ABORIGINAL HERITAGE

COMMENT	PROPONENT RESPONSE	DOCUMENT REFERENCE
1.	Blacktown Council considers there has been insufficient consultation with the OEH to provide confidence to Blacktown Council and objects to the proposed impacts on an area of high Aboriginal significance.	<p>The OEH has reviewed the application and submitted a separate submission.</p> <p>The OEH did not object to the application and confirms in their submission (dated 21/7/2015)):</p> <ul style="list-style-type: none"> ▪ The assessments have demonstrated an appropriate level of Aboriginal community consultation, as recommended by OEH, which conform to the Aboriginal Cultural Heritage Consultation Requirements for Proponents 2010 ▪ The assessment of Aboriginal cultural and archaeological heritage values has been undertaken in accordance with other current OEH guidance material including the Guide to Investigating, assessing and reporting on Aboriginal Cultural Heritage in NSW 2010. ▪ OEH is satisfied the Test Excavation carried out on EFW South has been adequate to appropriately investigate and document the likely archaeological resource at this location where harm is proposed by this development. ▪ The preservati

Figure 1 - 132kV Route Overview and Cable Entry to Sydney West Substation

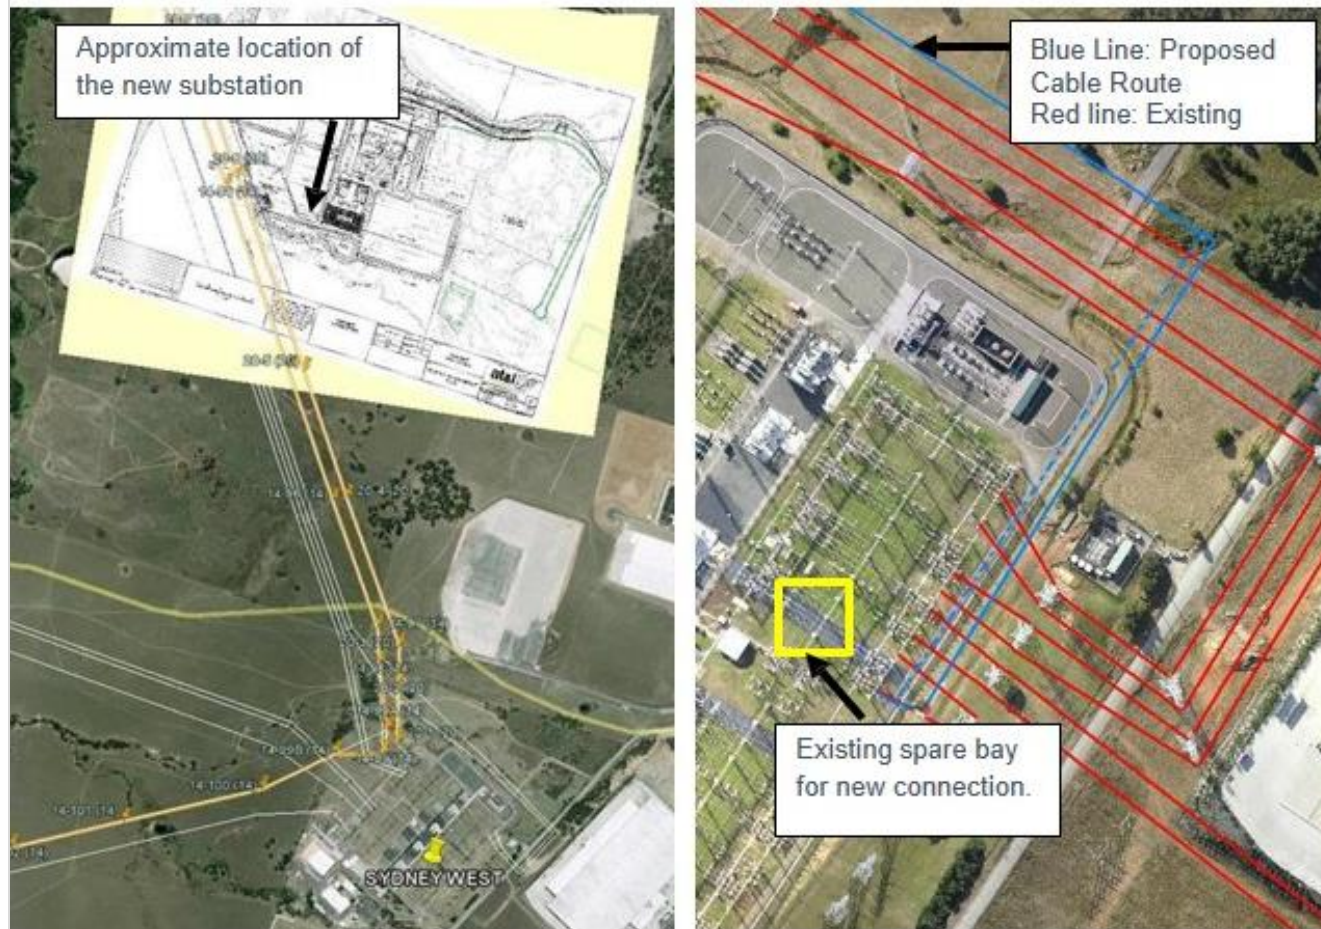
A 20m length of easement for Transmission Line 20 adjacent to the buffer zone surrounding Sydney West substation is currently not in TransGrid's name as highlighted in Figure 2 below. As part of this project a 20m length of new 6m wide easement is required within this section.

Access will be facilitated by existing easements and access tracks. Should additional access requirements be necessary for construction of the cable, this would be negotiated as required.
